AMENDMENTS TO THE DRAWINGS

REMARKS

Claim 1 now recites a cardiac pacemaker arrangement comprising:

Fig. 5

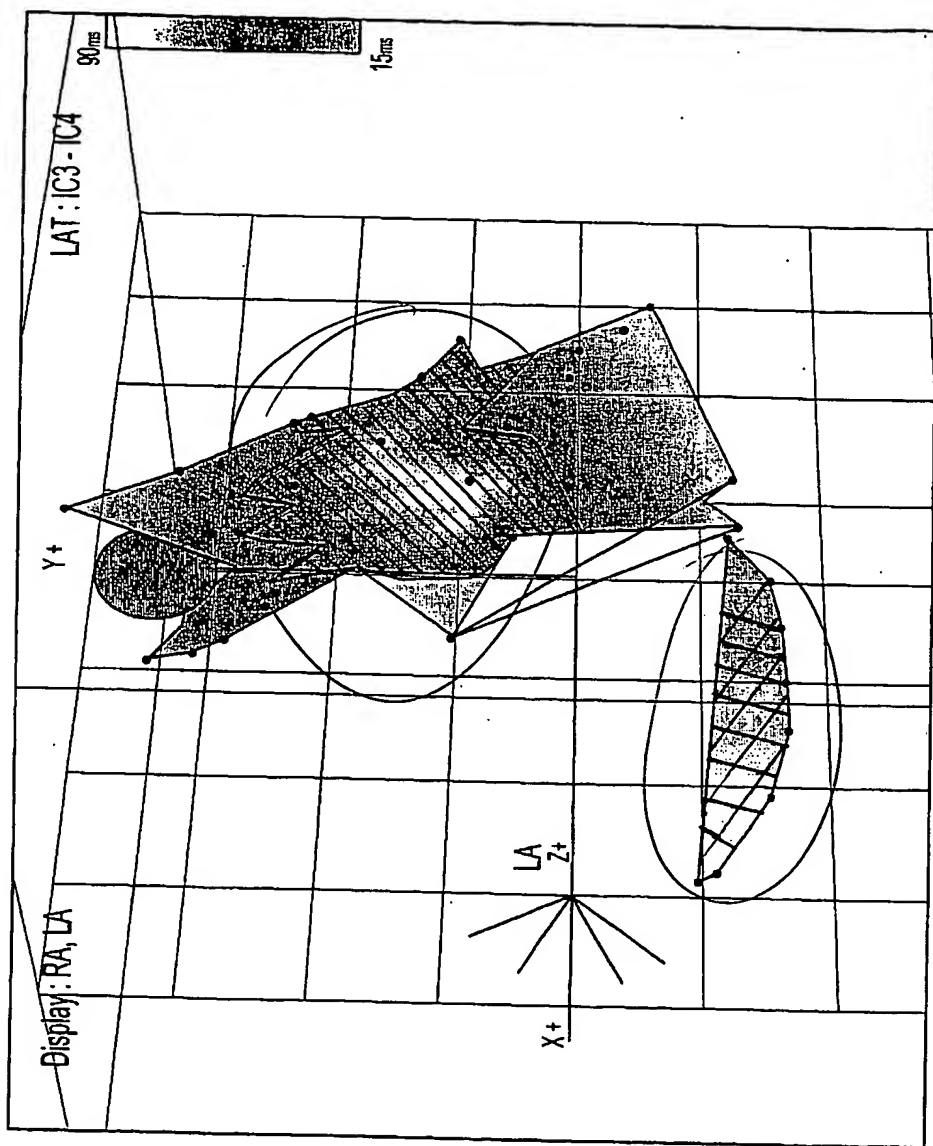
The attached two sheets of drawings include changes to Figs. 3A-3B and Fig. 5. These sheets replace the original sheets including only Figs. 3A-3B and Fig. 5, respectively. In Figs. 3A-3B, the vertical reference lines have been added back in since they were on the original figures and inadvertently left out on the formal drawings. In Fig. 5, the "square-marked" area and the "hatched" area, referred to in paragraph [0037] of the specification, have been clarified since the previously submitted black and white copy of Fig. 5 did not clearly indicate these areas. No new matter has been added.

Figs. 3A-3B and Fig. 5 have been amended herein to clarify certain aspects of the drawings and to correct minor problems with the drawings as described above herein. No new matter has been added. Applicant respectfully requests that the amended Figures be entered.
